# **MEMORANDUM**

Re: Giant's House - Akaroa | RMA/2020/2000

Quality Assurance Statement		
This document has been prepared for the benefit of Christchurch City Council. No liability is accepted by ViaStrada Ltd, or any of its employees or sub-consultants with respect to its use by any other person.	Prepared by:	Axel Downard-Wilke
	Reviewed by:	John Lieswyn
	Project Number:	1139-03
	Project Name:	Giant's House RMA application
	Version:	01

Figure 3-2: Bus turns into Rue Cachalot forward and then backs out

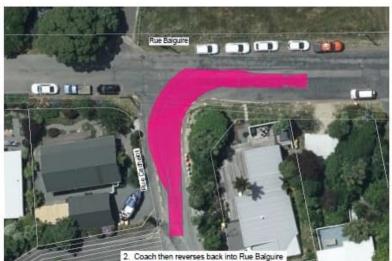
I appreciate that bus movements are a contentious issue. It needs to be stressed that buses have been servicing this site for many years and what is being proposed through the conditions is to formalise how this is being done. One objective of that is to ensure that passengers get off the buses facing their destination not having to cross the road. Another objective is to prevent buses using random driveways to turn around. That said, I will discuss bus stop options as well. It has been agreed with the applicant that bus access to the site can be achieved by coaches coming up the hill turning into Rue Cachalot forward and then backing out; this is shown in Figure 3-2. The bus would then reverse up to the site. A bus parking area is to be established outside number 74 Rue Balguerie. In conjunction with mitigating measures discussed below, this is an acceptable solution.
